Love Field Element Aloft Hotel

UDPRP Review Summary DRAFT 11.22.13

Urban Design Peer Review Panel

PROJECT: West Love Development

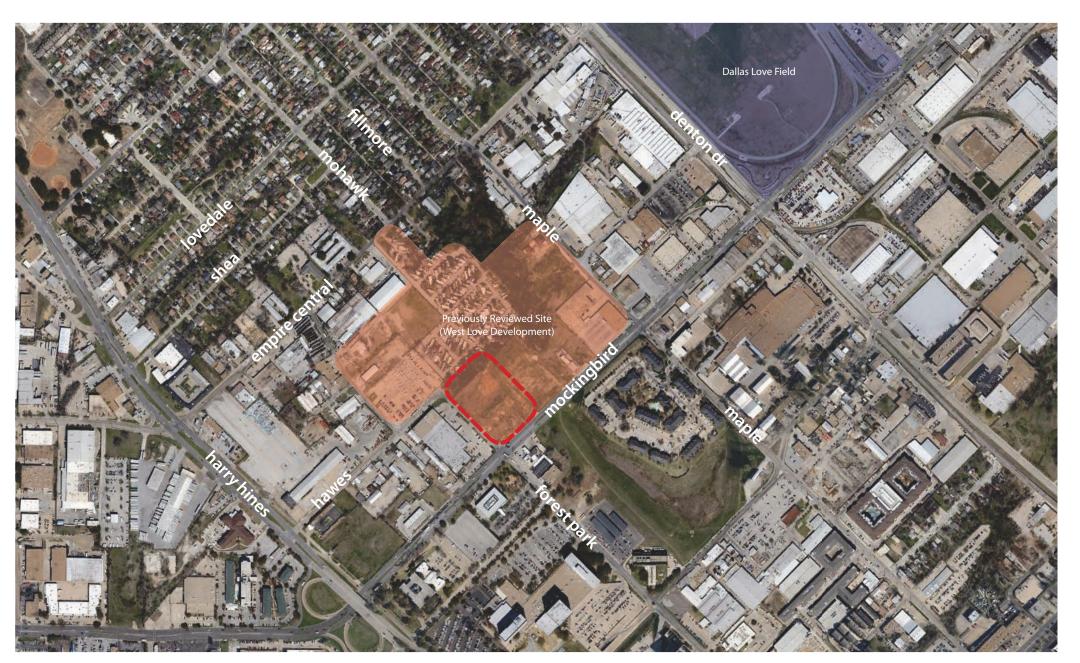
[1] Careful attention should be given to the Hotel drop-off area as it relates to the public realm and potential activation of the ground level of the project -

Consideration should be made as to the most appropriate treatment, dimensions and location of the hotel drop off area. As currently shown, eliminating curbs, minimizing impact on pedestrian walkability, and subtle integration as a component of a pedestrian oriented public realm will be critical considerations in achieving an active and walkable urban edge.

Site Plan - Overall scale 1" = 150'-0"

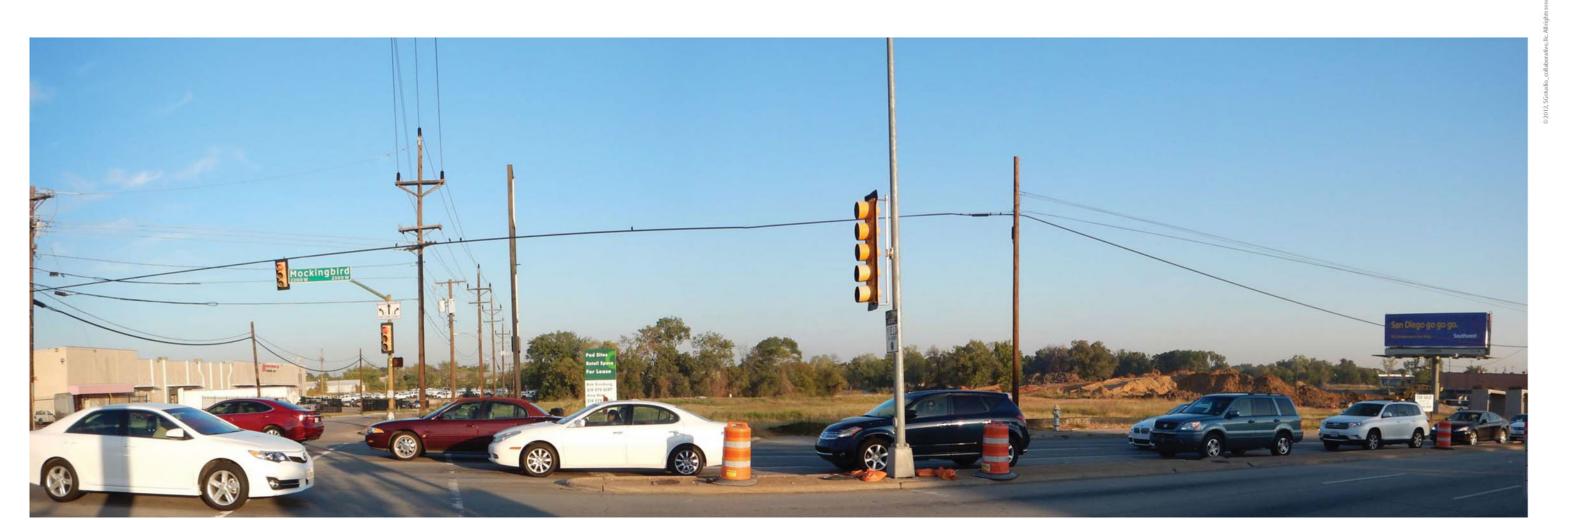
- [1] The panel concurs with the attention and design direction of main drives through the site, as well as the character of proposed buildings.
- [2] The panel emphasizes the importance of the site as the first major development north of Mockingbird and as a precedent for future development.

- [3] The panel encourages that further study be made to the overall site plan to explore opportunities to create more of a district and a less conventional retail feel for the development.

- [4] Consider location and orientation of the hotel in a more integrated fashion, potentially pulling the building forward towards mockingbird.
- [5] Consider enhanced landscape and integrated storm water management to mitigate open fields of parking and consider integrating the parking configuration into the overall development to as an opportunity create more of a parking plaza condition rather than a conventional parking lot.

- [6] Consider opportunities for alternative orientation of large retailers to mitigate their distance to Mockingbird.
